NSW Independent  
Planning  
Commission

Pitt Street South  
OSD

INTERNAL AMENITY  
SUBMISSION

18 March 2021  
Final

### Proposed:

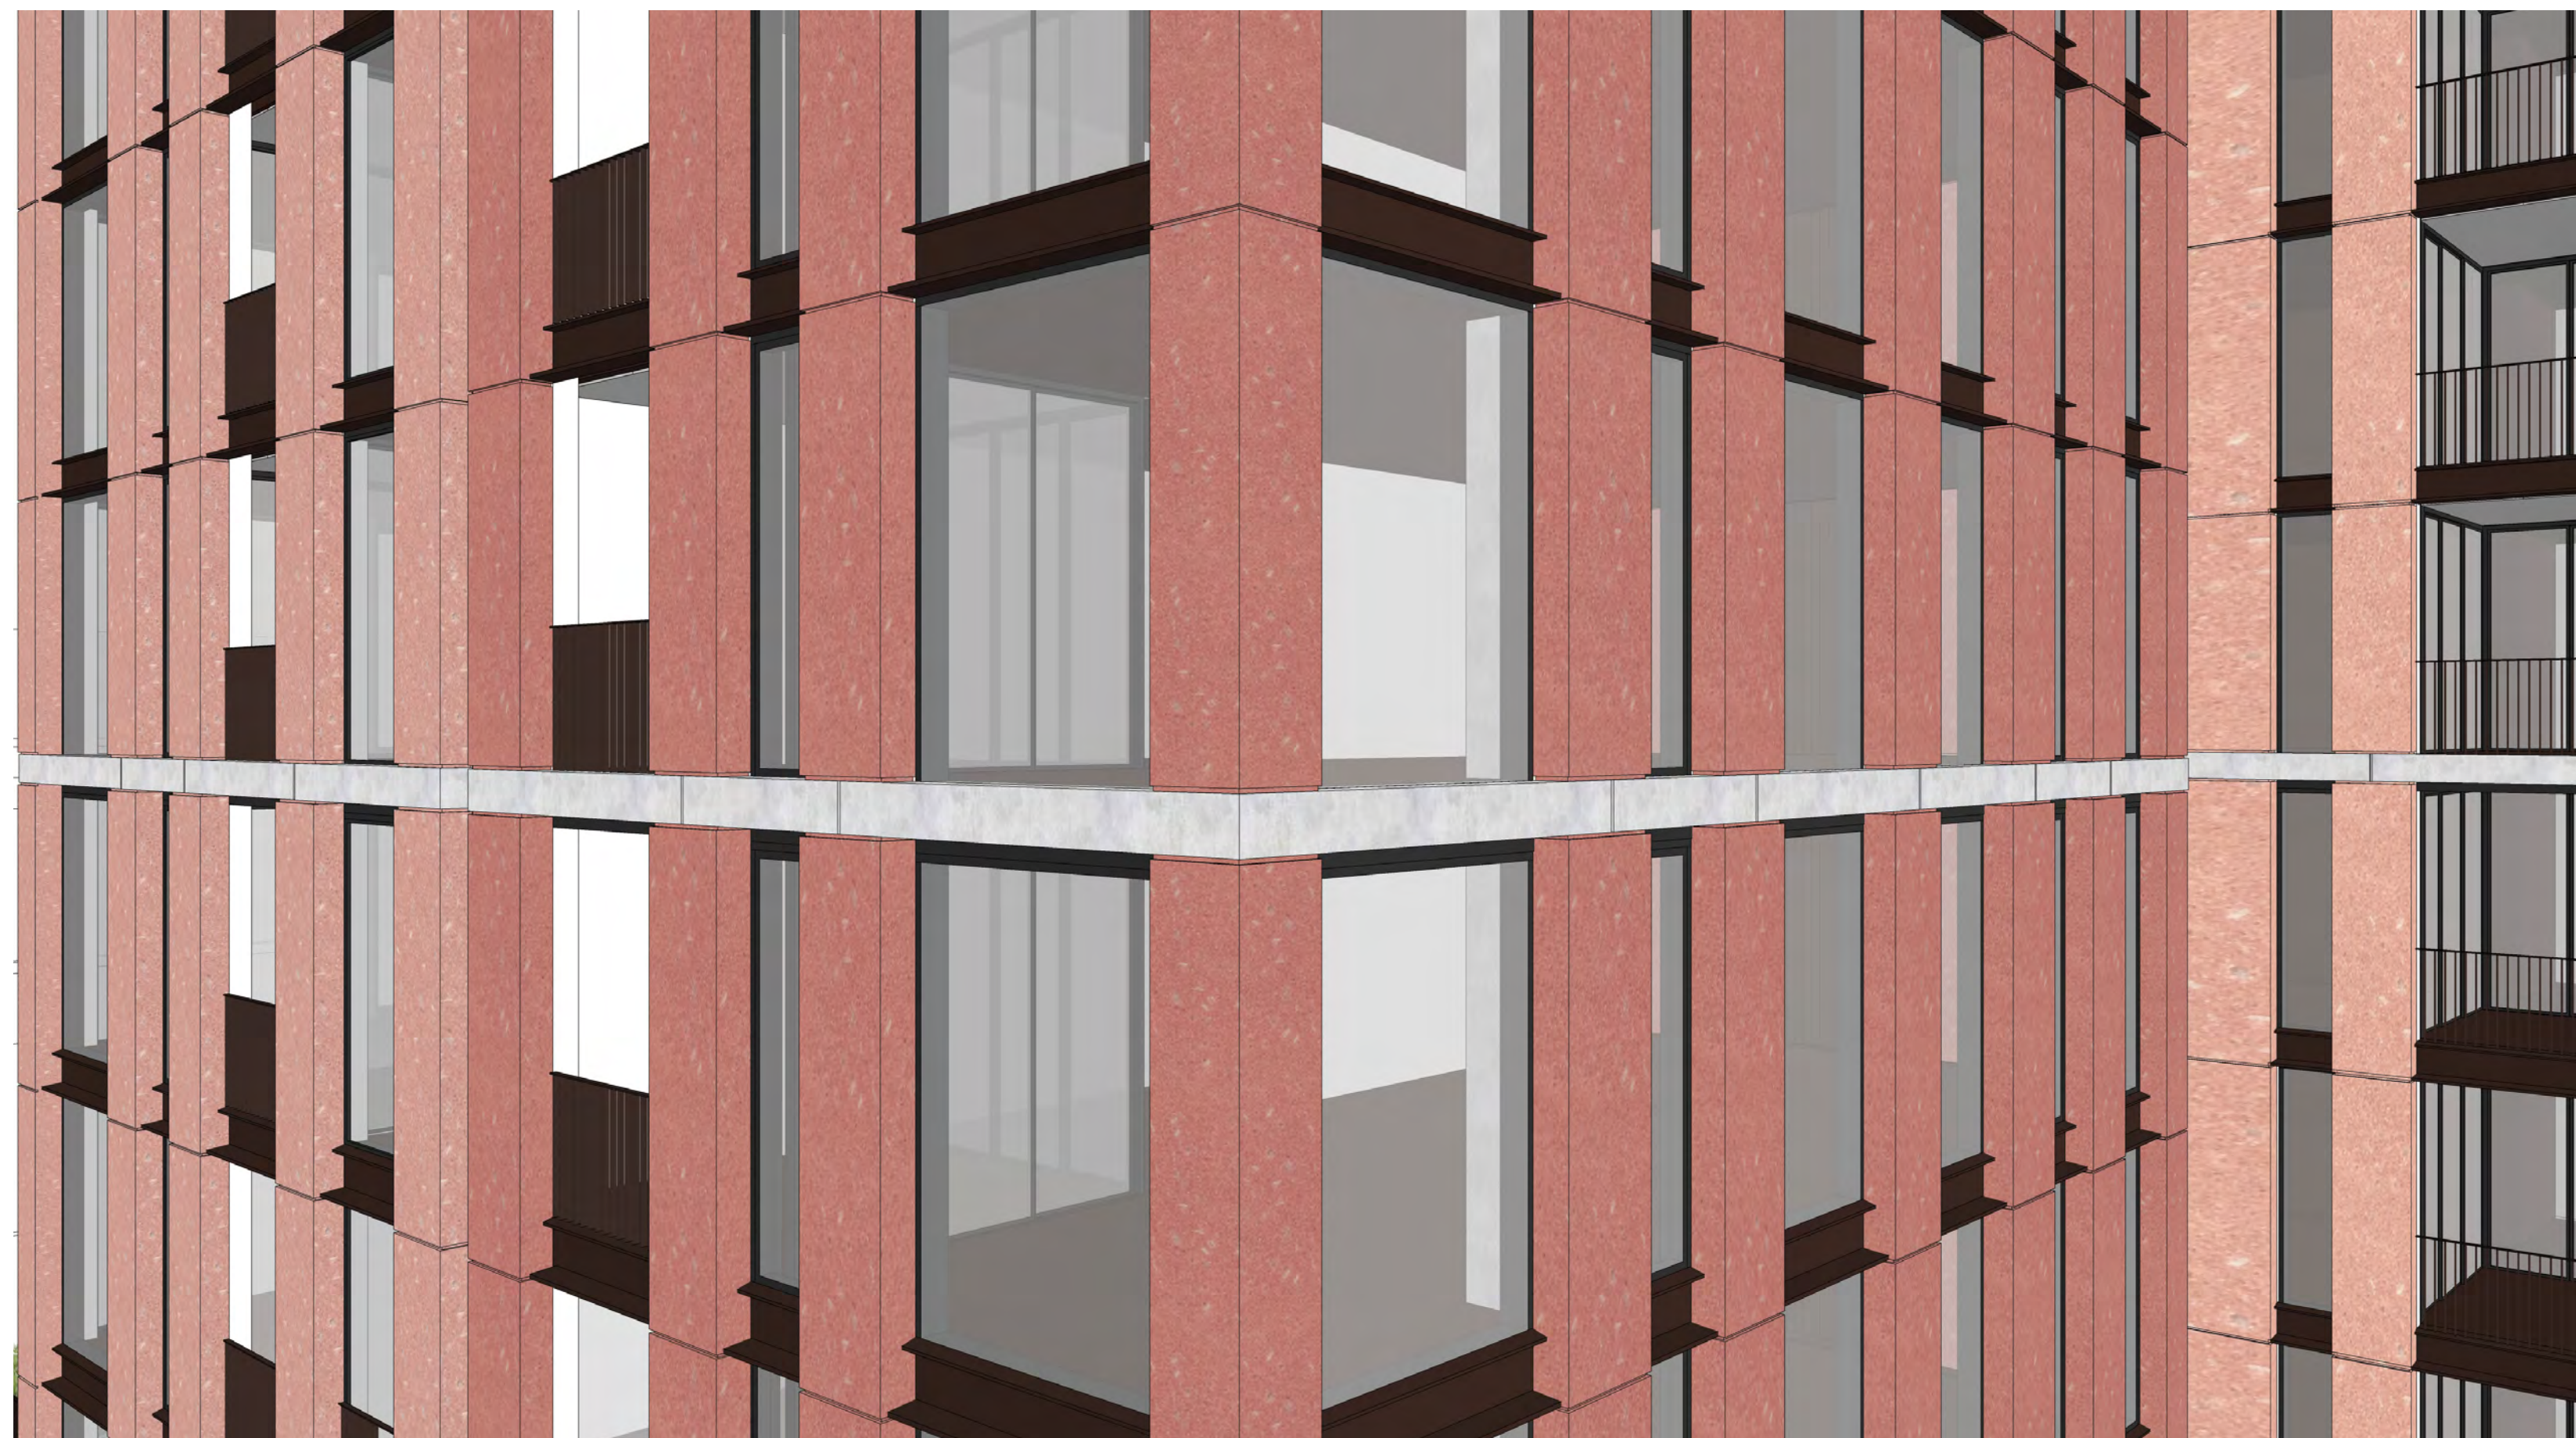
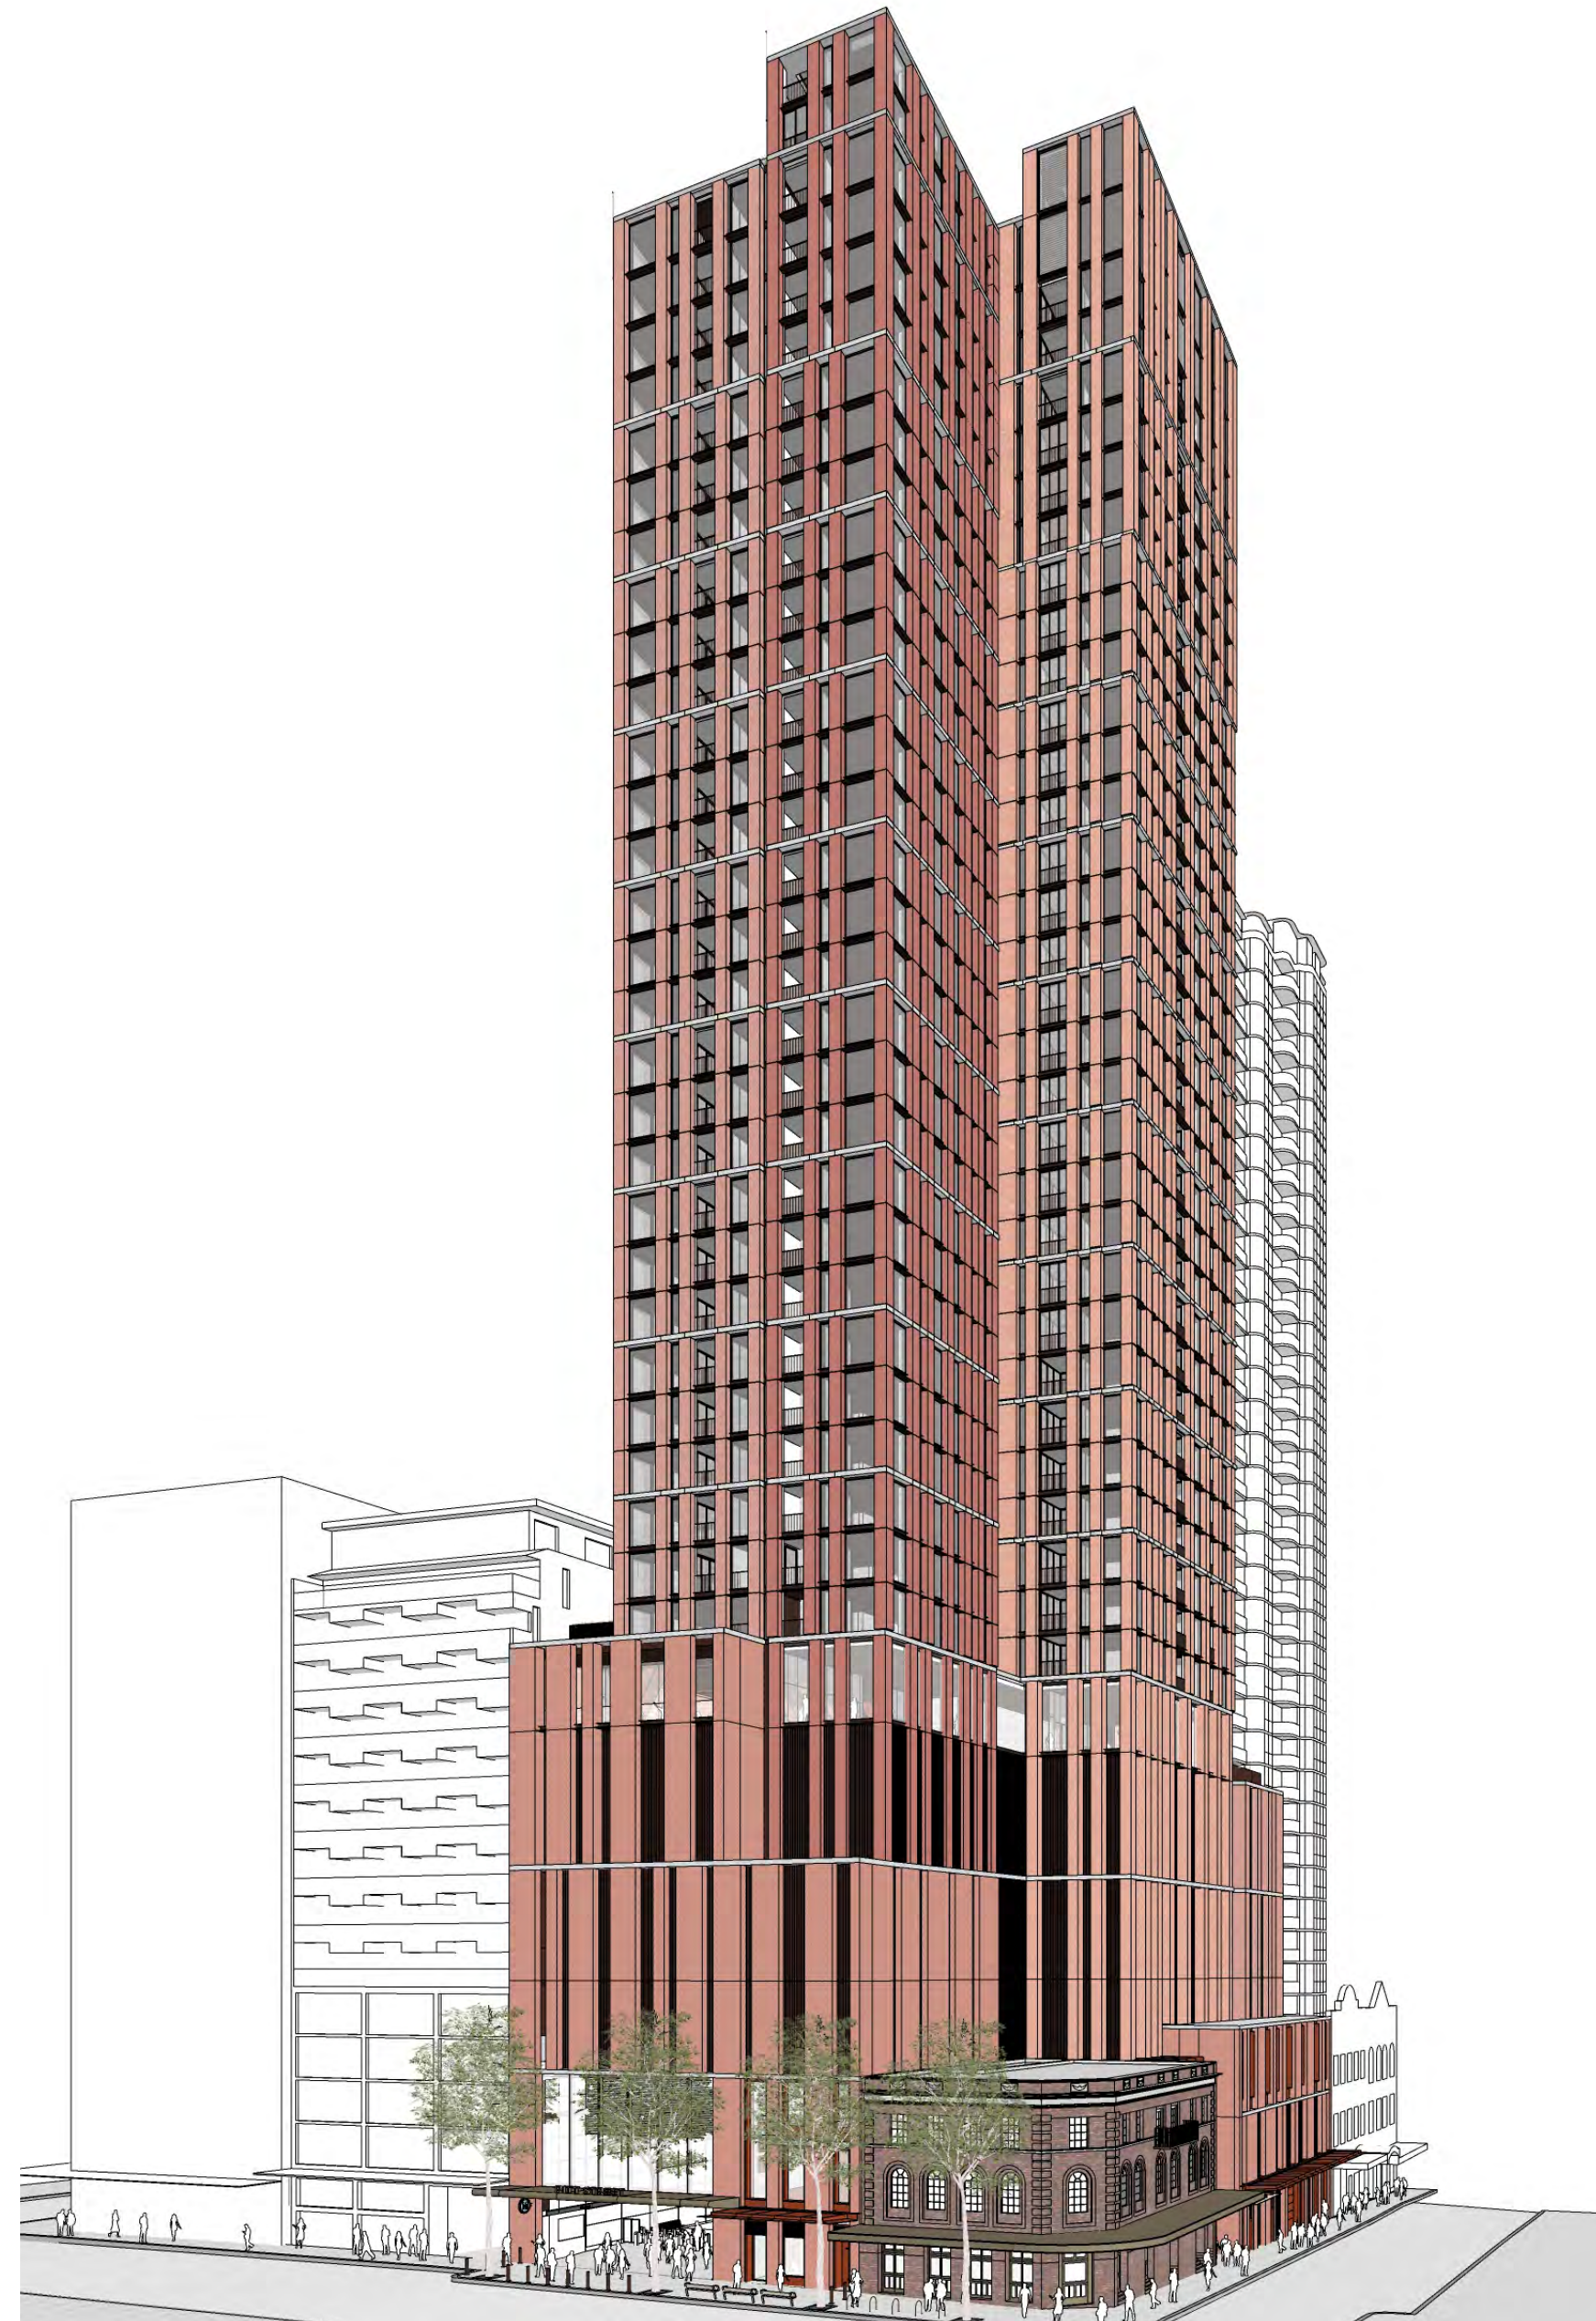
- The majority of these change were rejected by the Panel, “The Panel reasserts its earlier assessment that the minor encroachments outside the building envelope create no adverse impacts on privacy and solar access. Whilst the Panel applauds the project teams’ efforts to reduce these encroachments, the Panel believes the reduced depth to the GRC facade elements diminishes the architectural quality of the facade, and should be calibrated to the building orientation (e.g. maintaining the deeper panels on east/west)”

*Review the appropriateness of the proposed projections beyond the approved building envelope with respect to any additional impacts when compared to a complying development, including further consideration of any:*

- \* overshadowing impacts to adjoining residential properties*
- \* privacy and visual impacts resulting from further encroachments on minimum building separations*
- \* streetscape impacts*
- \* ongoing maintenance of boundary conditions.*

- DD on GRC from 450 x 800/900 to 250x 900*
- Reduce depth to comply with town planning envelope*
- Improved consistency of width (800 v's 900)*
- Increased solar access to living rooms*
- Refined locations to create regularised proportions relating to internal rooms*

- 450mmD x 800mmW GRC

- 250mmD x 800mmW GRC
- 200mm reduction in depth

- 450mmD x 800mmW GRC

- 250mmD x 800mmW GRC
- 200mm reduction in depth
